ROYAL PINE HOMES – SITE INSTRUCTION

SITE INSTRUCTION NO.6.RP.INTERIORS			
PROJECT:	Hampton Place	LOCATION:	25 Baker Hill Blvd Stouffville, ON
DATE:	April 15, 2019	BY:	L. Renzetti

AMENITY KITCHEN
X-RAY VIEW 2

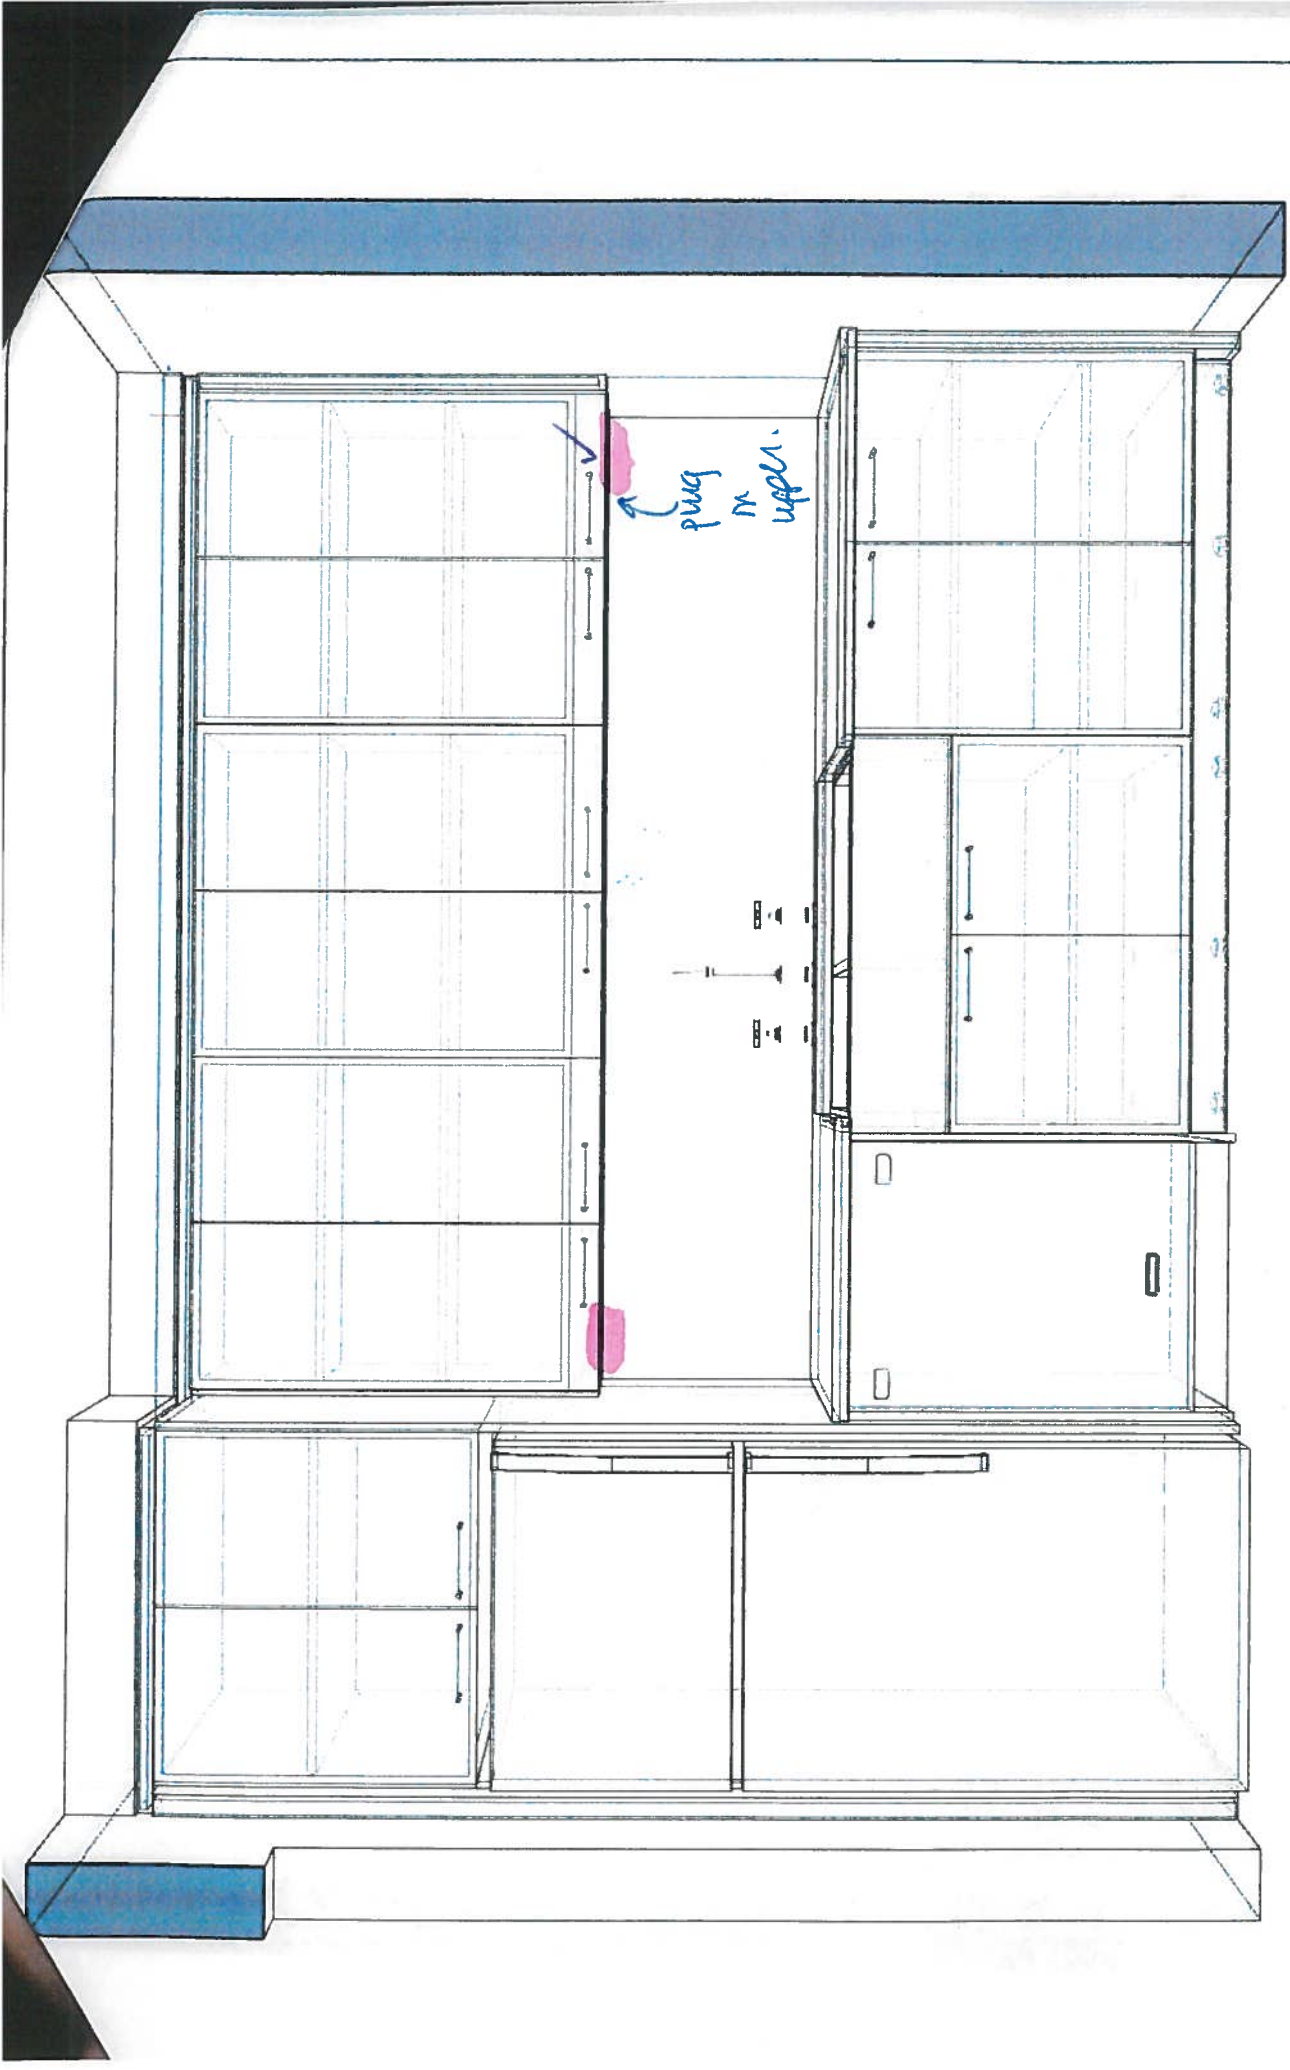
NO.	ITEM/DRWG NO.	DESCRIPTION
1.01	ID.304. Partial RCP Janitor & Concierge Strg	CHANGE: Delete t-bar ceiling as indicated in RP.INT.SI.04. Now drywall ceiling in both rooms. Change three (3) FL1 fixtures to FL surface mounted fixtures.
1.02	ID.304. Partial RCP Janitor	CHANGE: Delete crown moulding (used to be hall to mail room)
1.03	Dog Wash	CHANGE: Delete t-bar ceiling as indicated on ID 304. Now drywall ceiling. Change two (2) FL1 fixtures to FL surface mounted fixtures (as per email dated March 27.19 to O'Neil Electric).
1.04	Amenity Kitchenette Shop Drawings	CLARIFICATION: All receptacles mount in bottom of upper cabinets. Led strip lights at front of upper cabinets.
